**NOTICE OF ADDENDUM
ADDENDUM NO. 2**

**CONTRACT NO. 7939
MADISON MUNICIPAL BUILDING - RENOVATION**

This addendum is issued to modify, explain or correct the original Drawings, Specifications, or Contract Documents and is hereby made a part of the contract documents.

**EXHIBIT H
 S190**

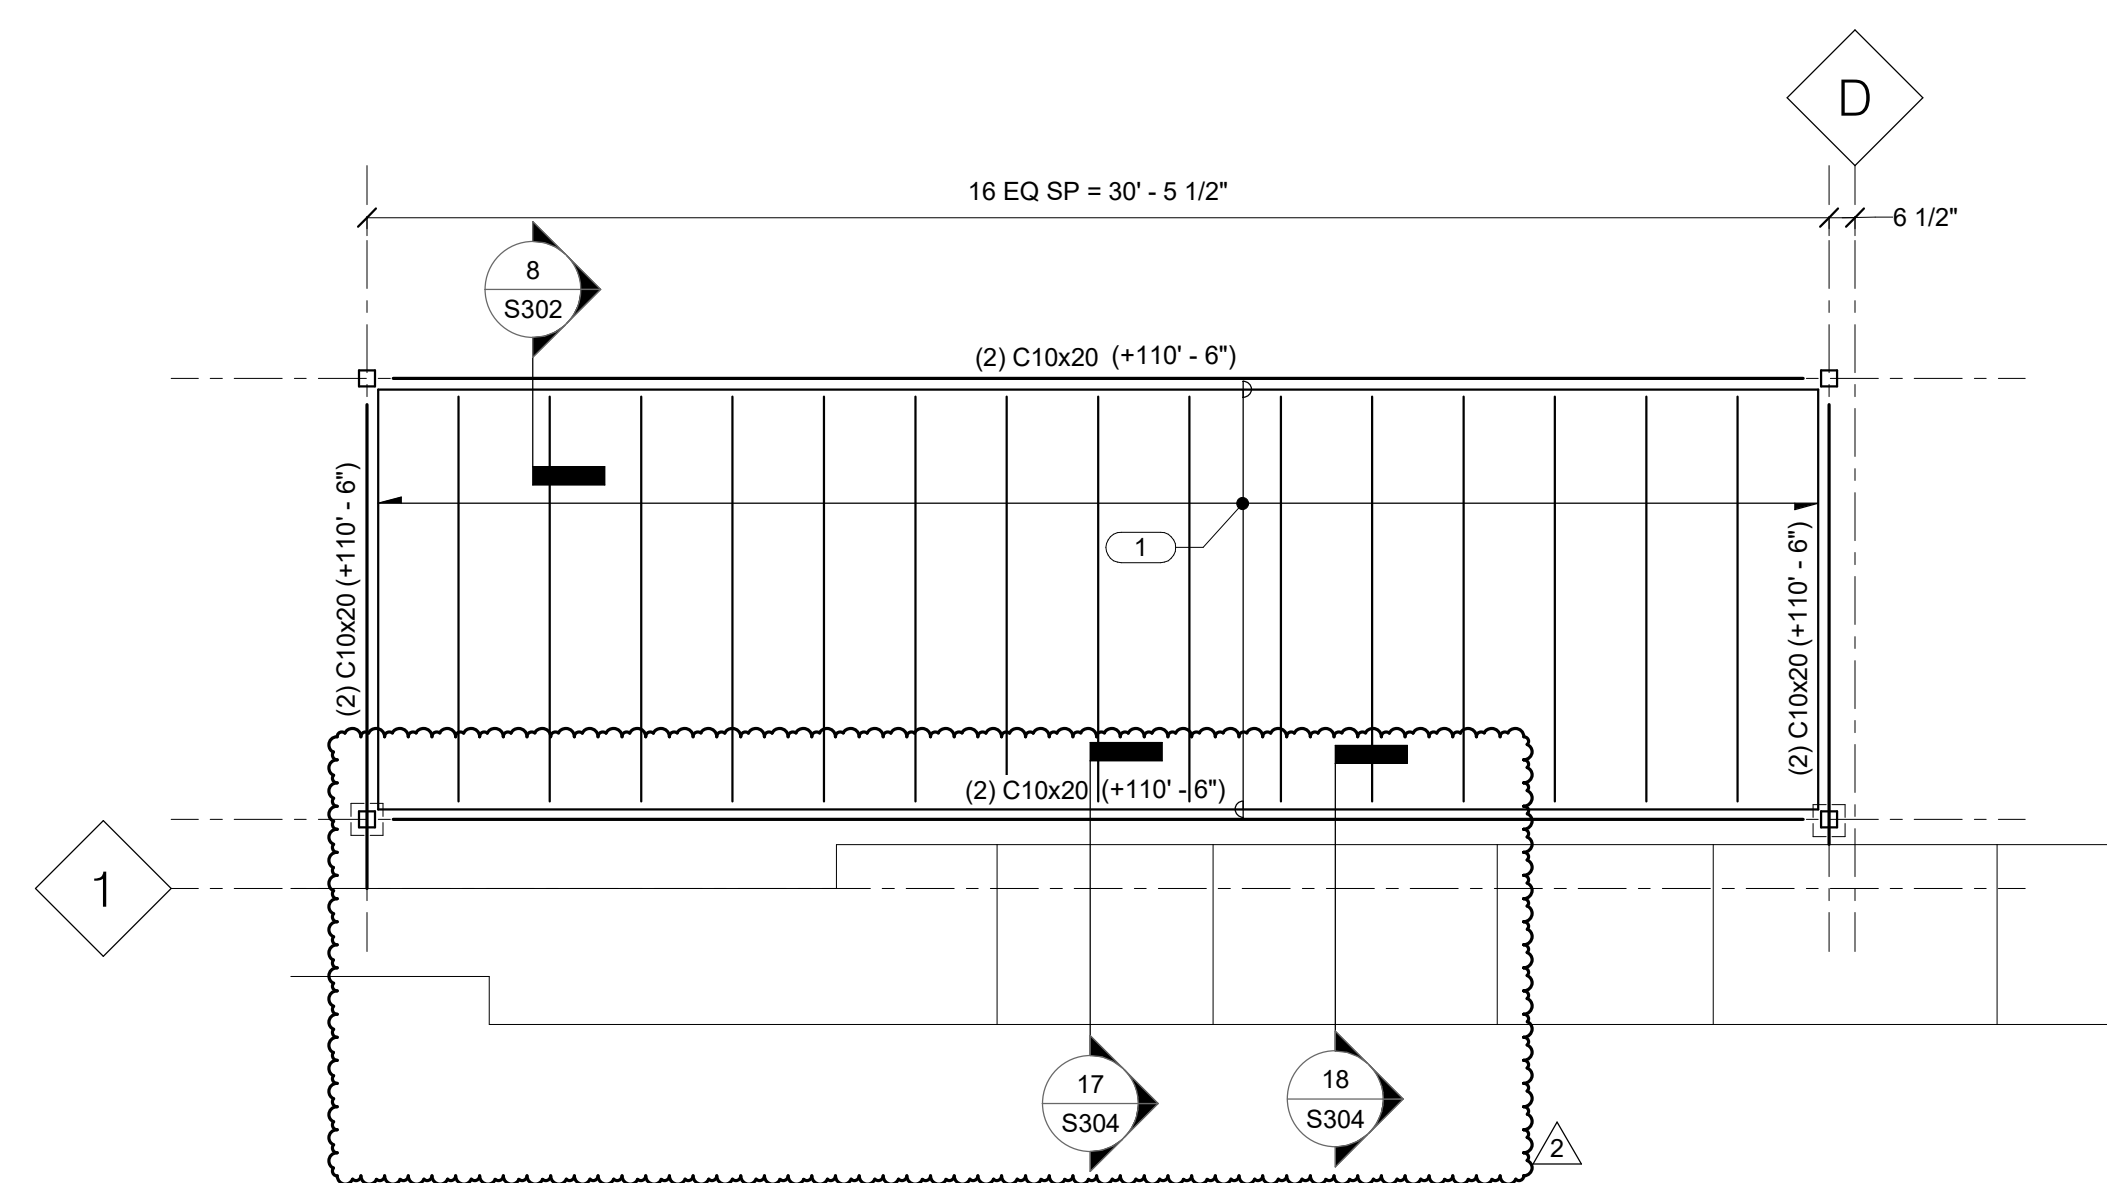
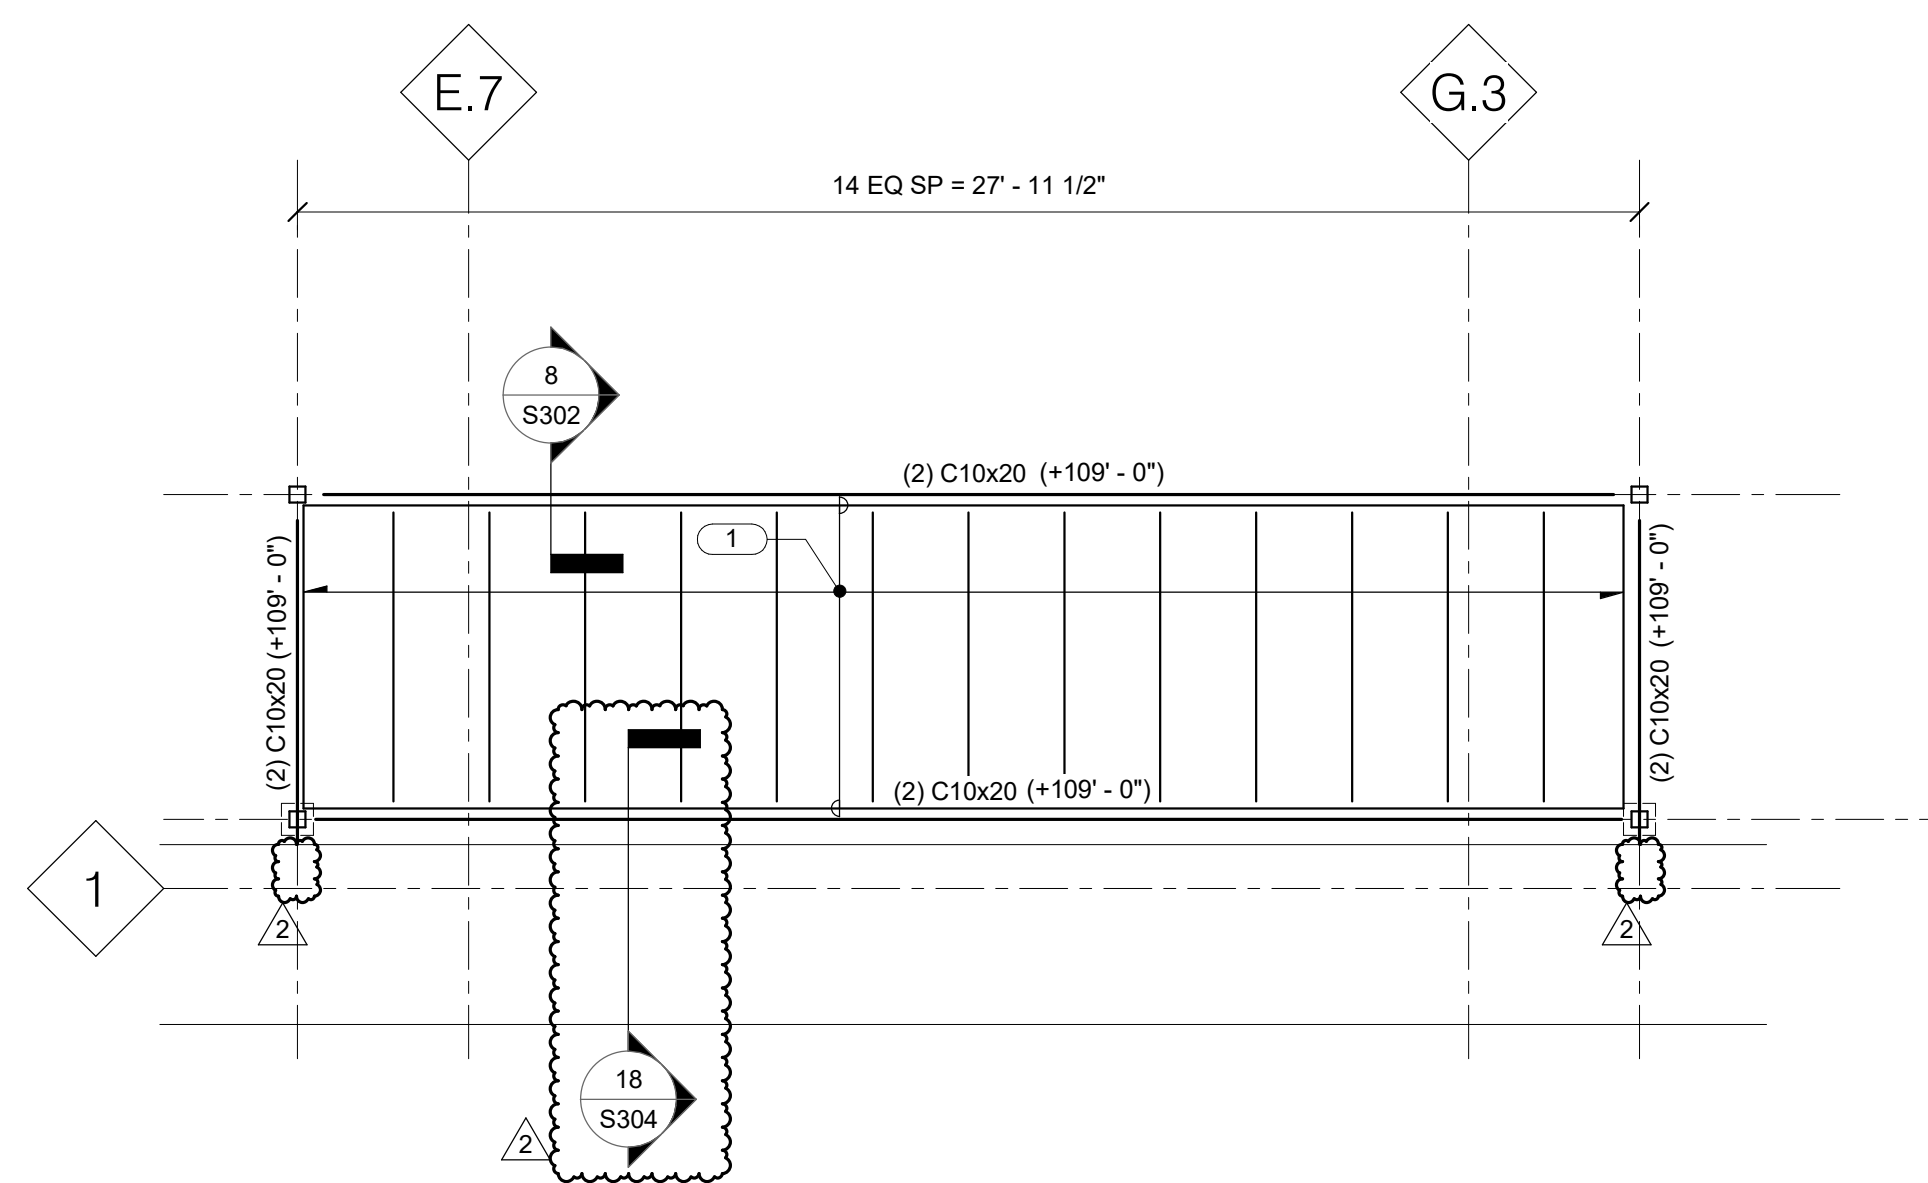
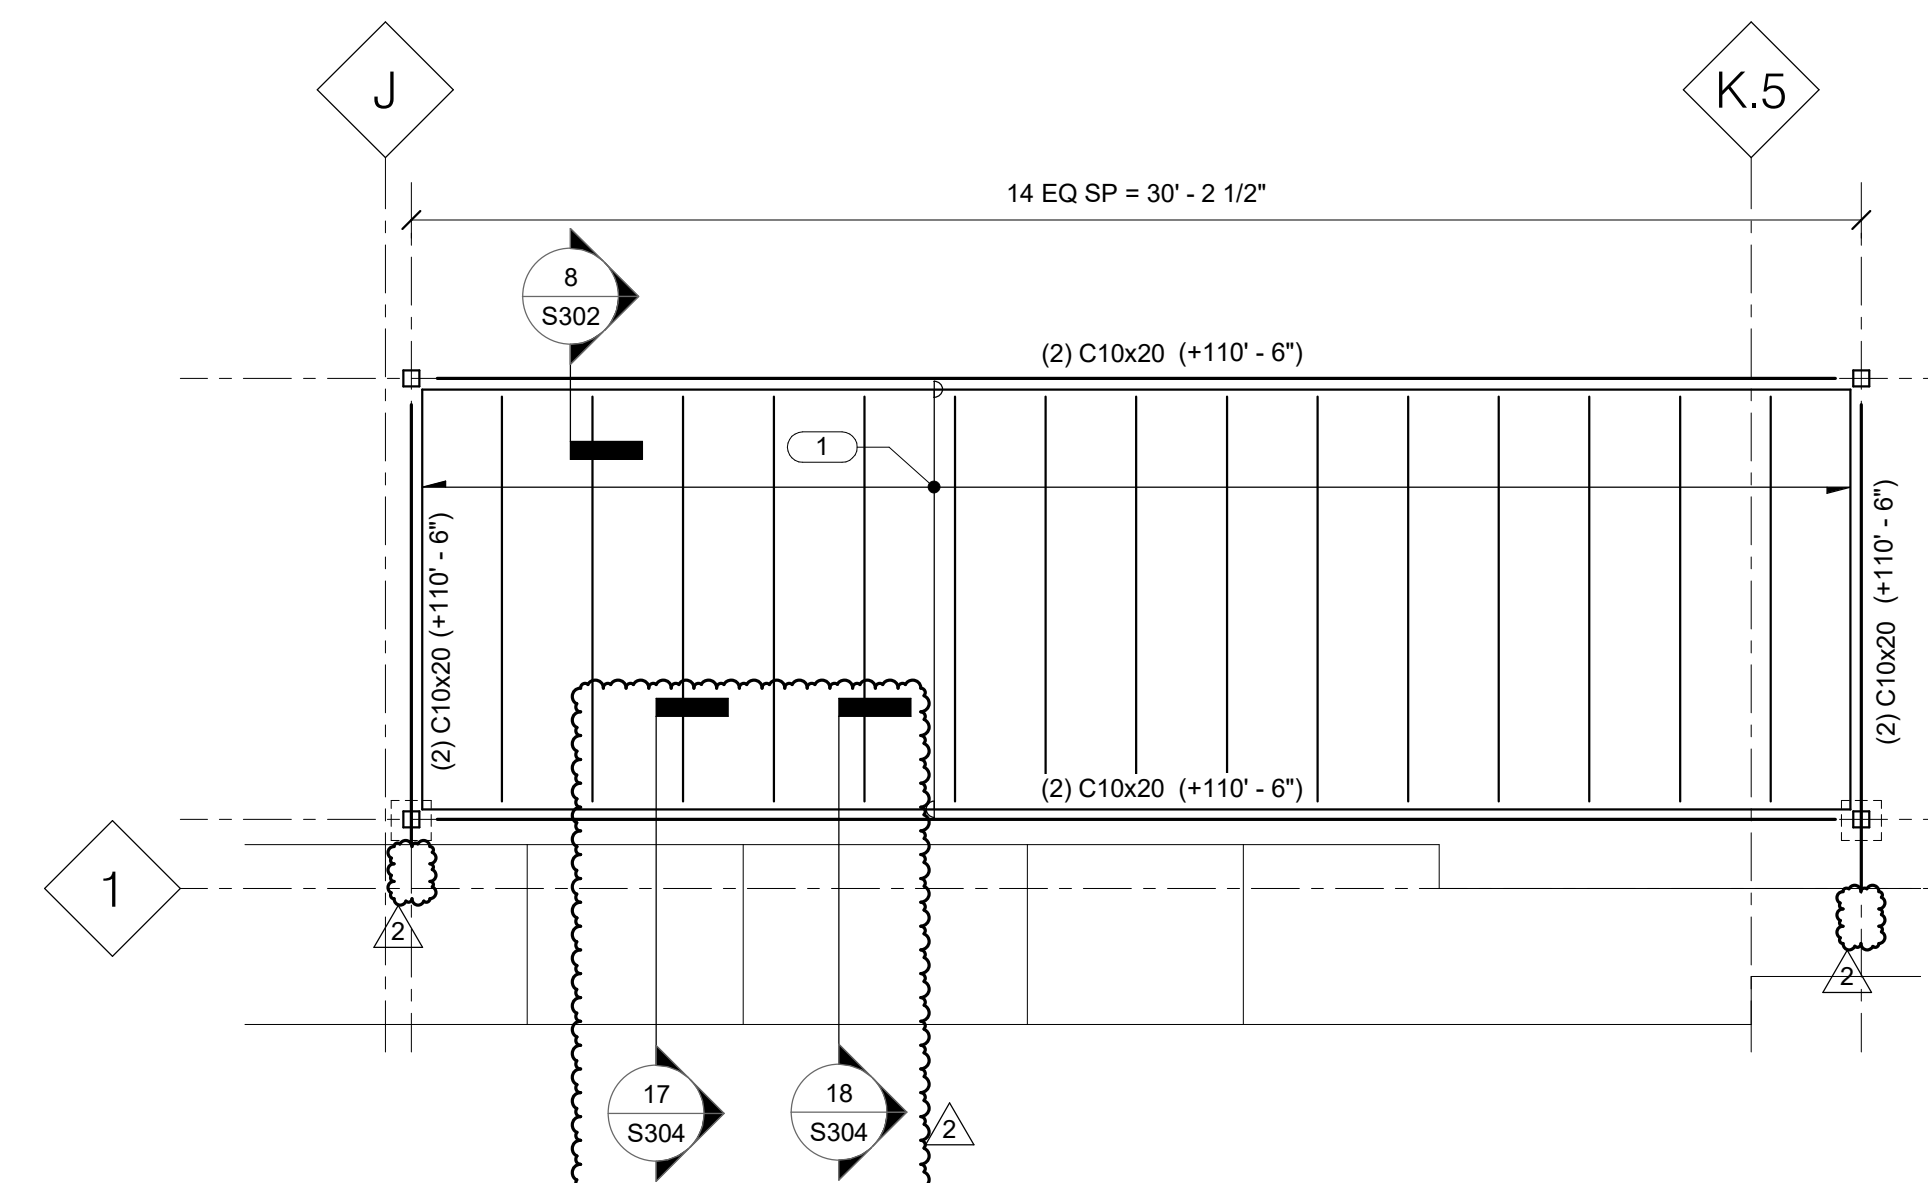
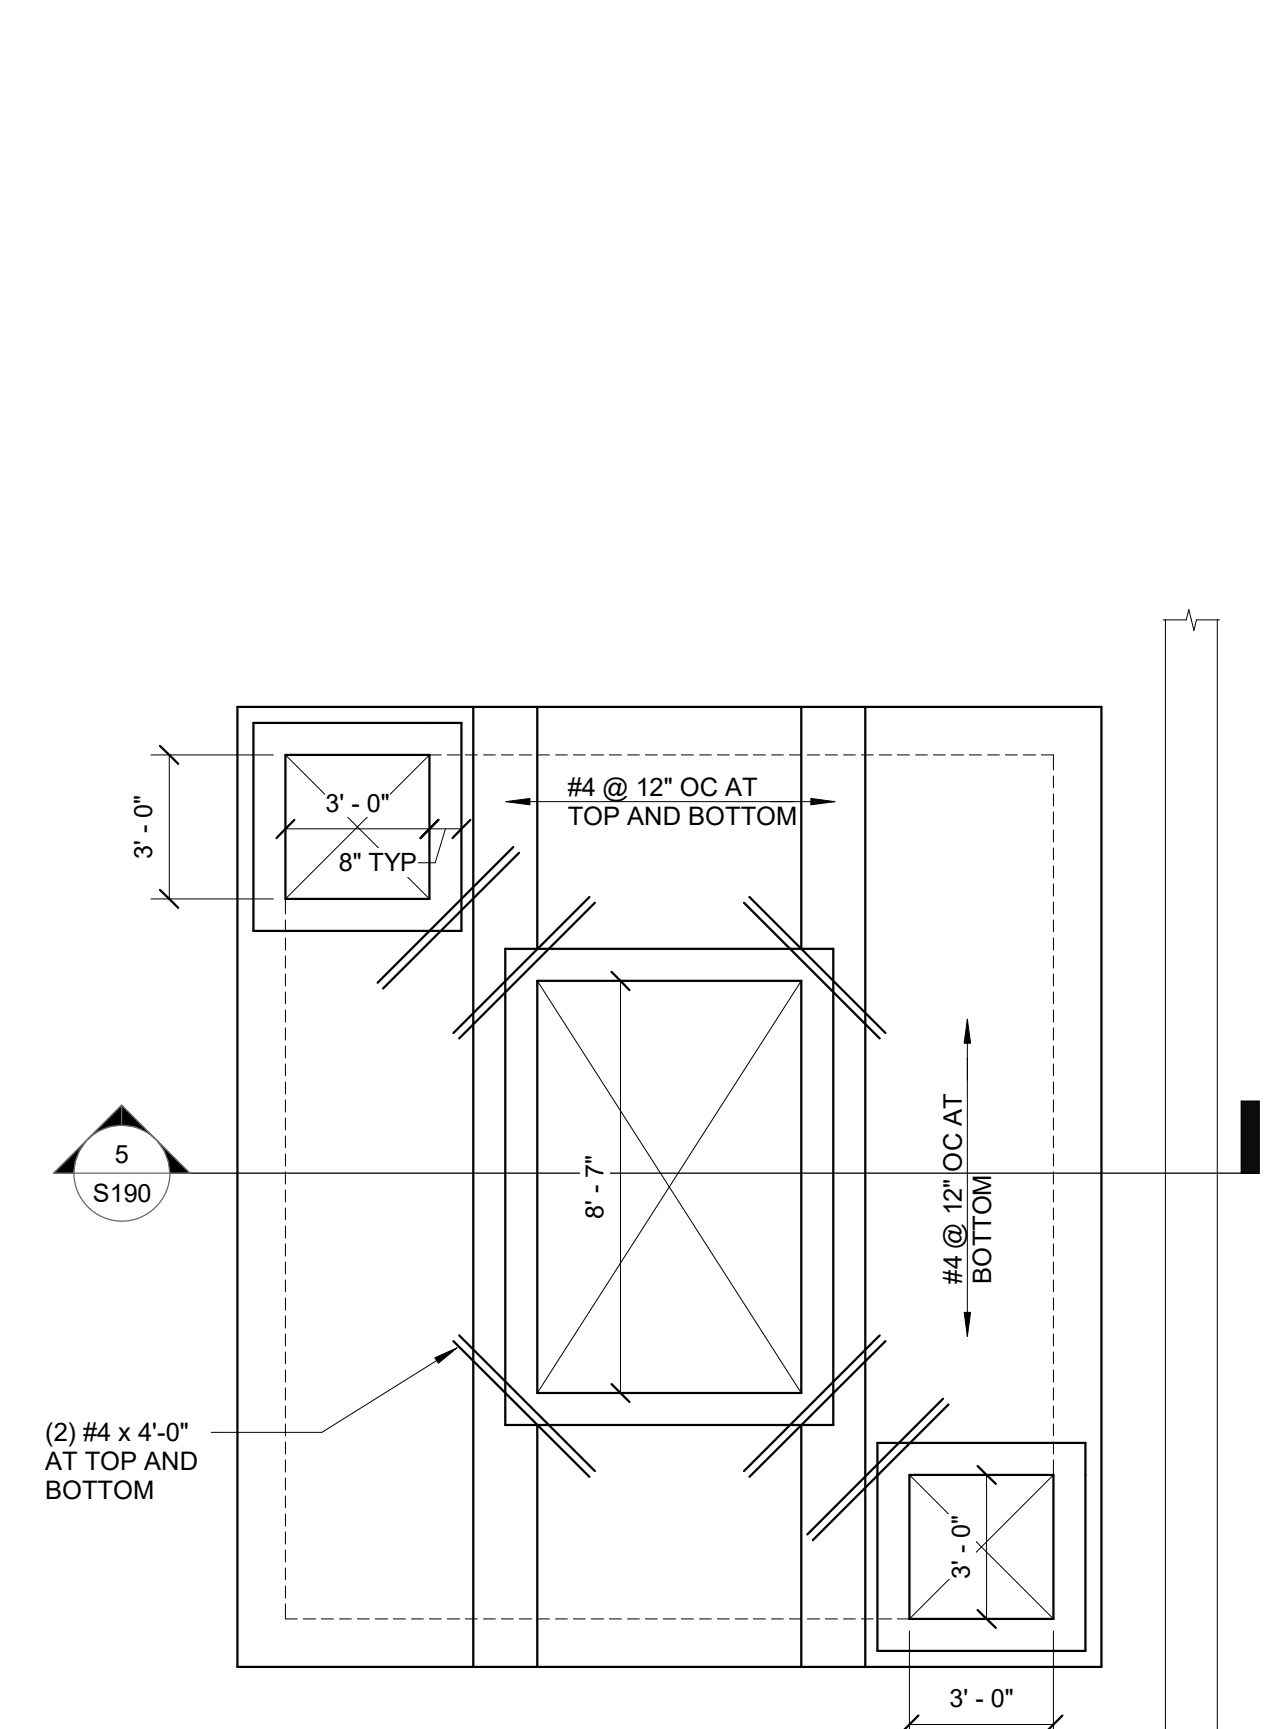
- a. **REVISE** enlarged ceiling framing plans per revised sheet S190.
6. Drawing S201 – FOUNDATION DETAILS
 - a. **ADD** dowel spacing in detail 6 to be 16” oc per revised sheet S201.
